ADDENDUM 1

DATE: March 29, 2024

IFB 13-24
Rockville Swim & Fitness Center Outdoor Recreation
Pool Renovations Project

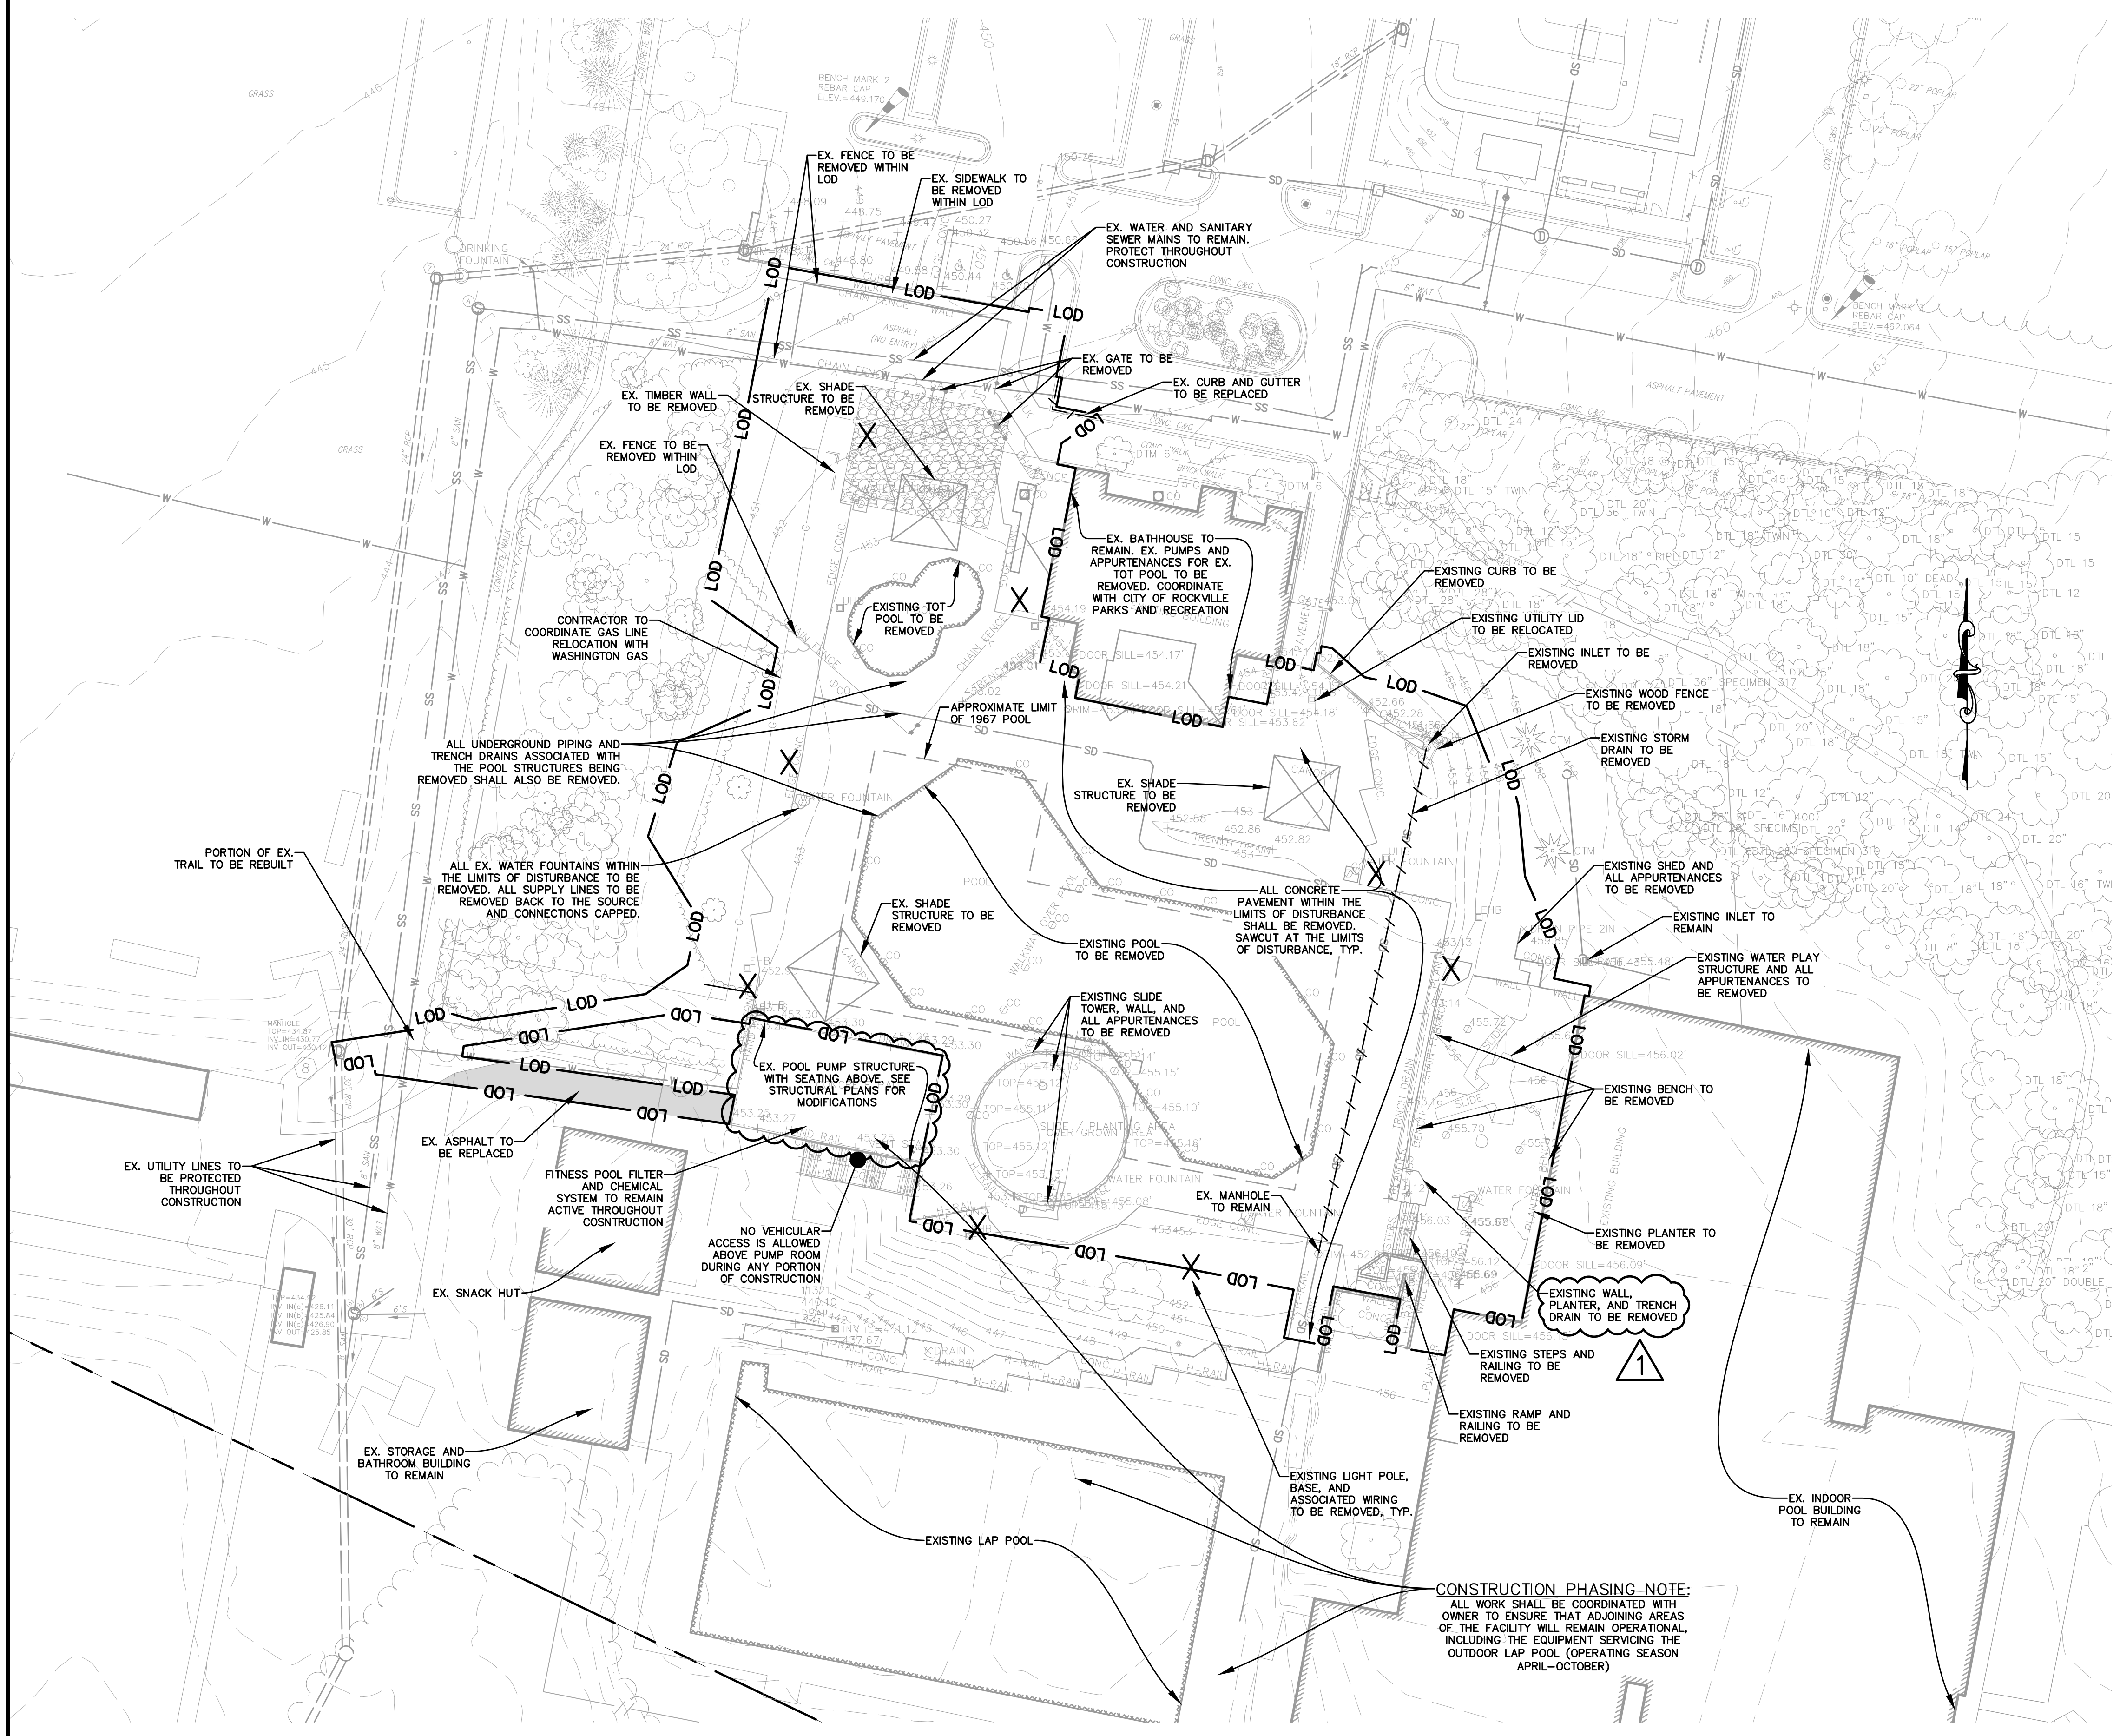
Sheet C-100 is labeled showing the “existing water play structure and all appurtenances to be removed” and “existing shed and all appurtenances to be removed.” This includes the removal of an underground water storage tank as explained in Note 18 on Sheet C-100. “When an item is stated to be removed, it shall include removal of any and all appurtenances above or below grade associated with said item.”

Drawing C-100 Please confirm we are to remove the existing concrete wall between the Existing Water Play Structure and the lower pool deck. The notes point to the adjacent stairs and bench, but not the wall itself.

Response: See updated Sheet C-100 Existing Conditions and Demolition Plan.

2 SANITARY SEWER PLAN
SCALE: 1" = 20'

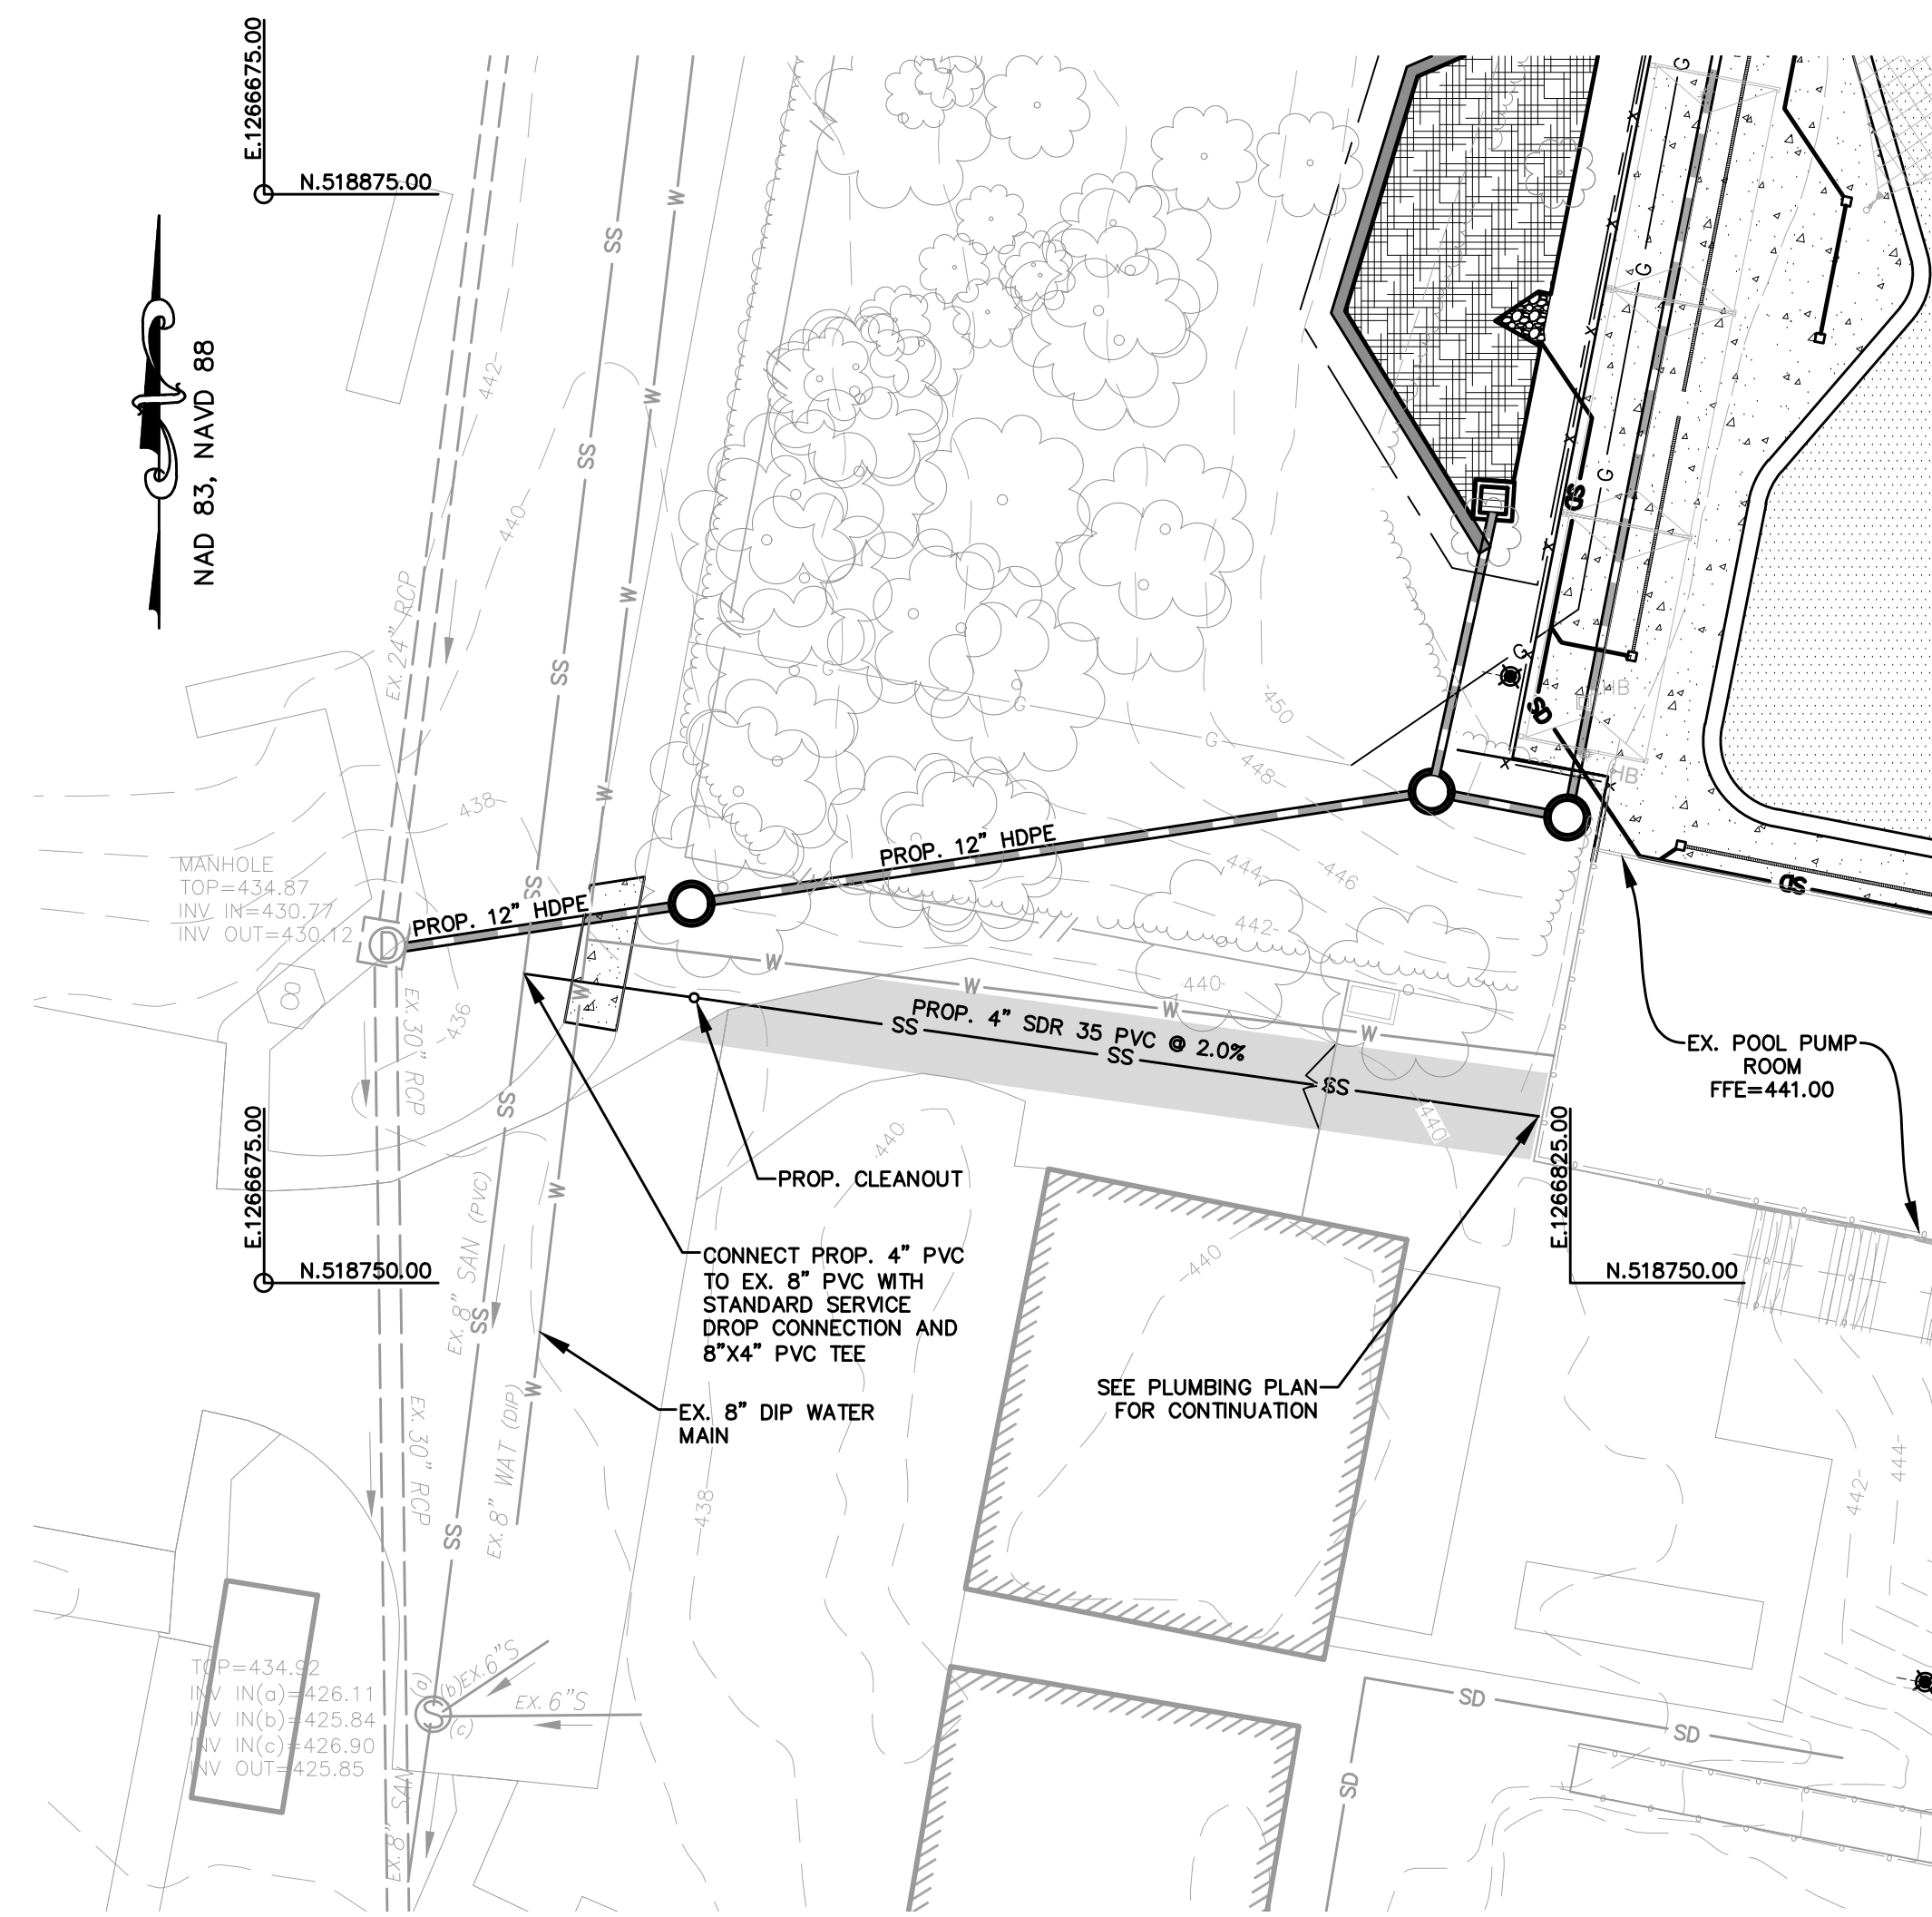
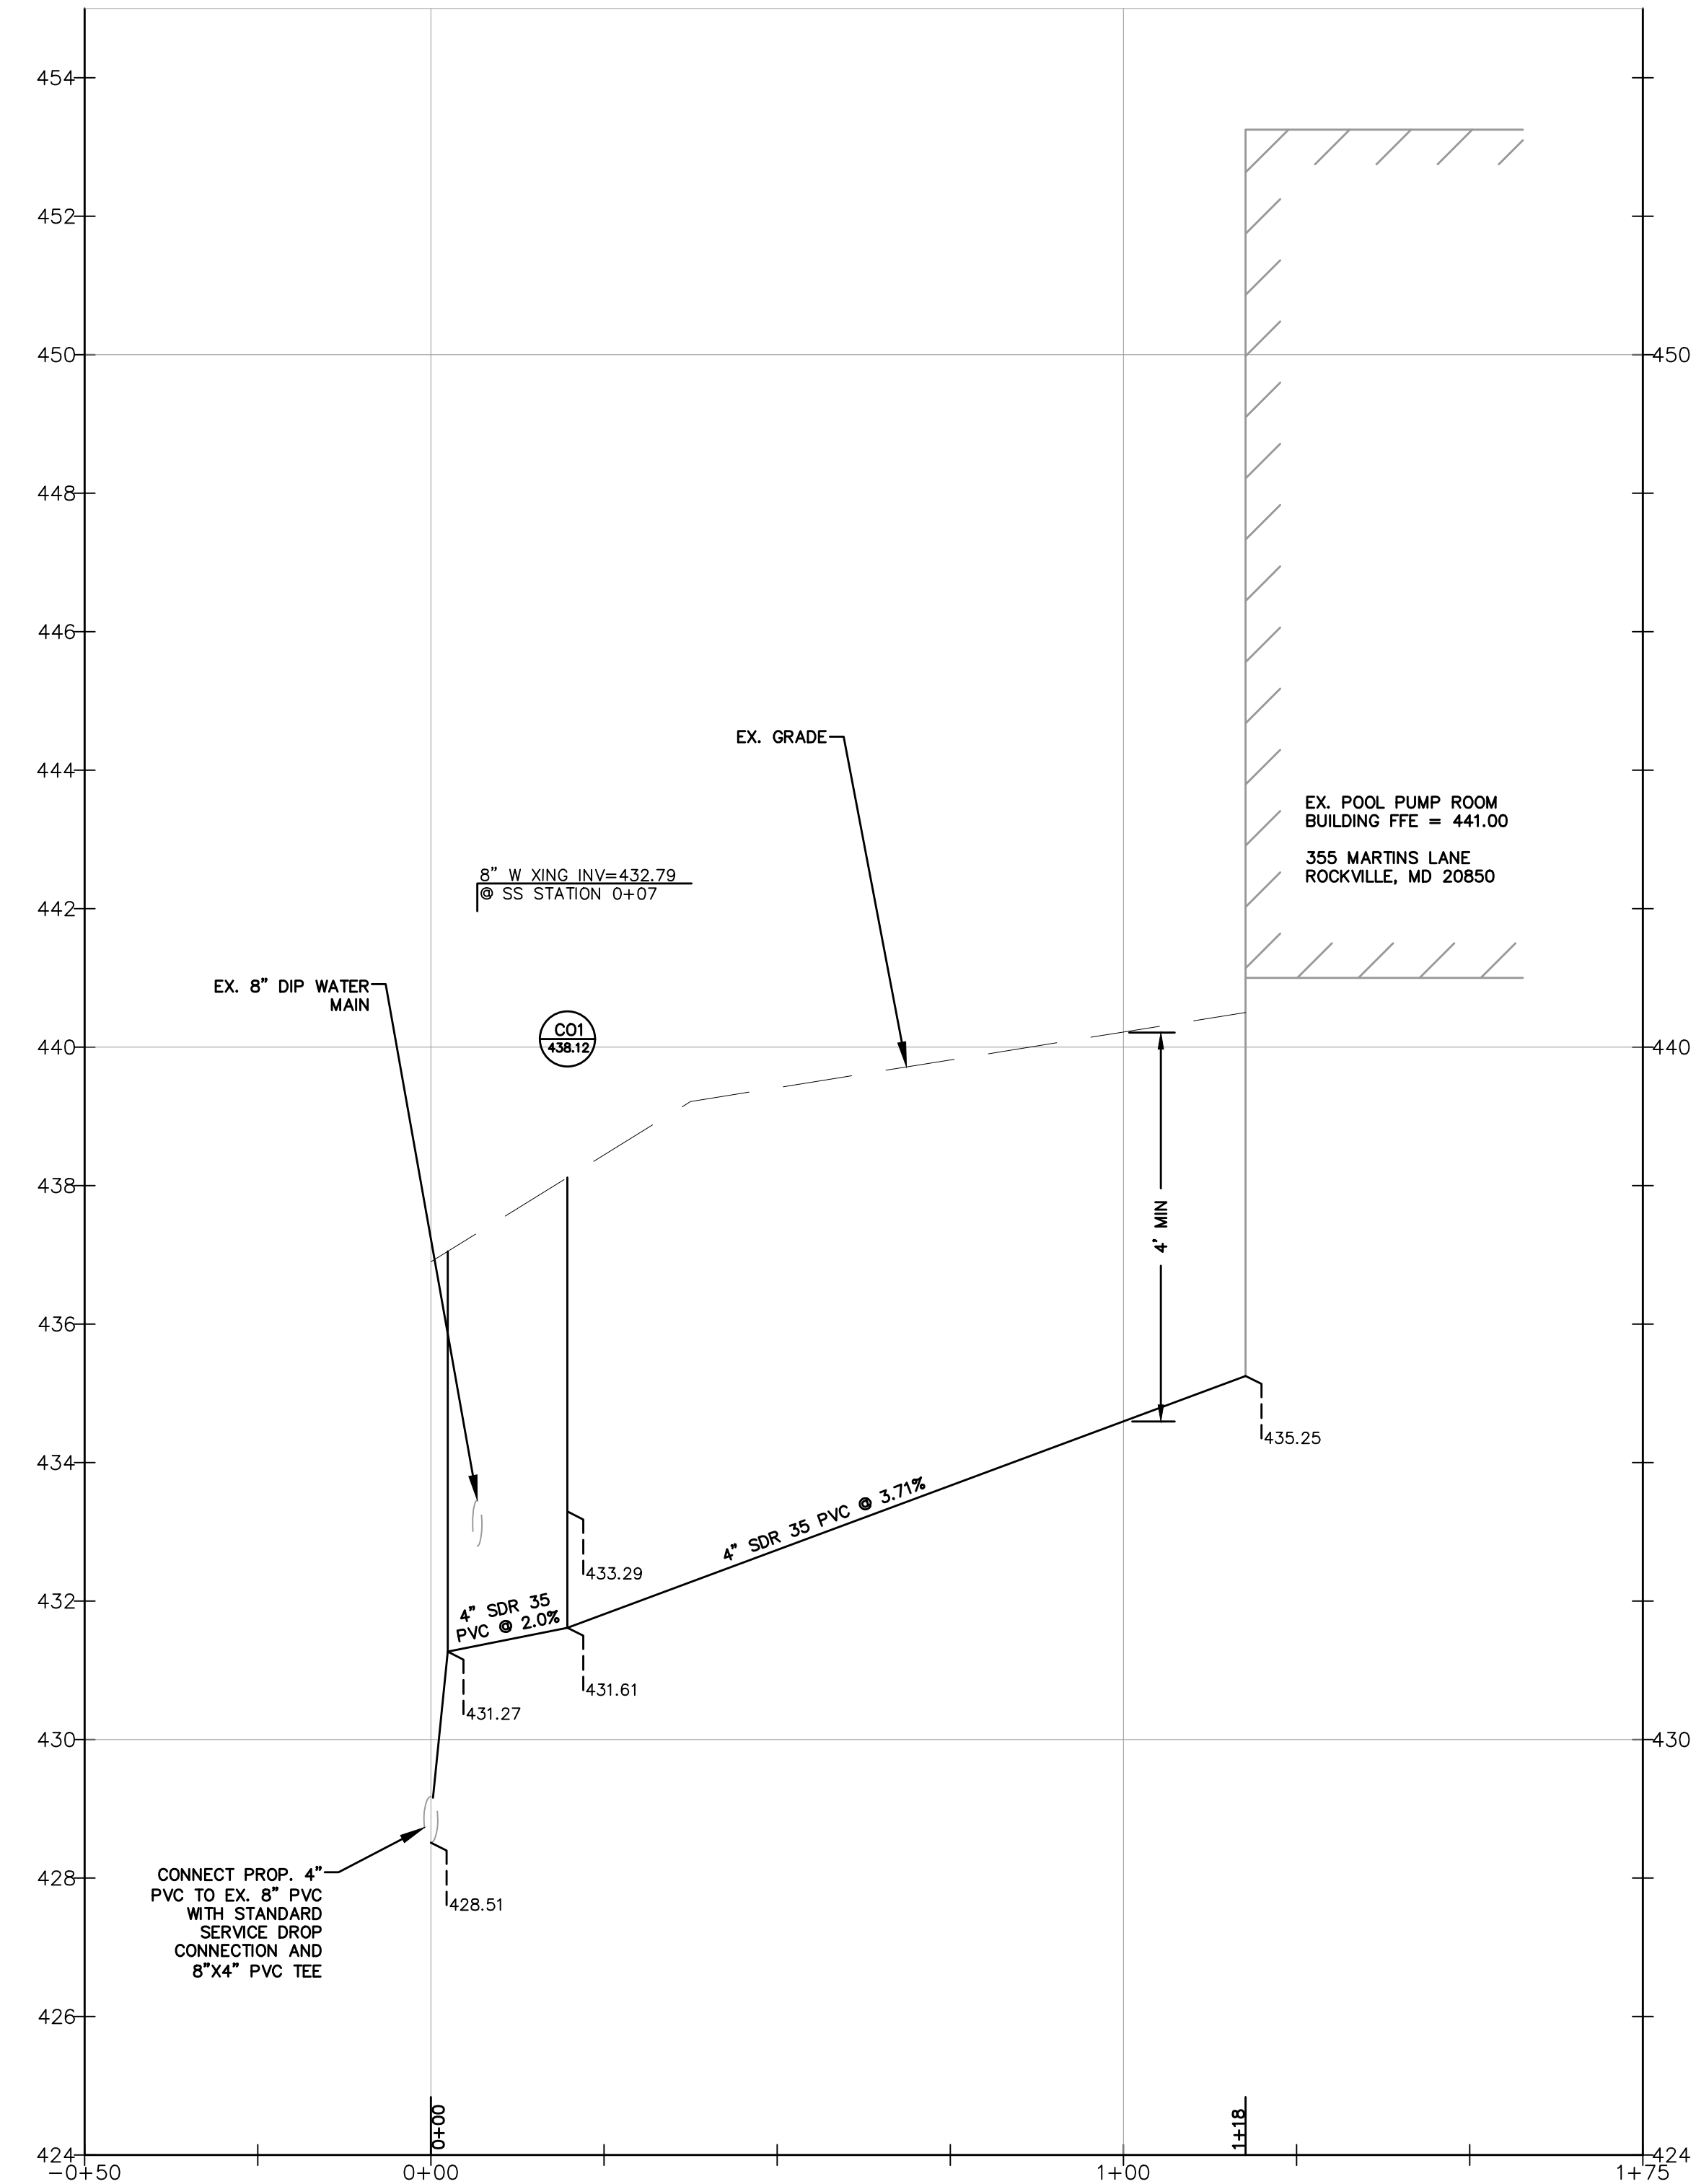
Page 642 (Sanitary Sewage Plan and Profile). This seems to be Storm Water Piping from Bio-Retention Pond to 24” RCP. The plan and pipe schedule both refer to Sanitary Sewer Piping. Please clarify.

Response: Sanitary Sewer Plan and Profile sheet shows the plan and profile view of the sanitary sewer connection from the pump house to the existing 8” sanitary sewer. The symbol is a line with “SS”. The proposed 12” HDPE storm drain is shown for reference on this sheet.
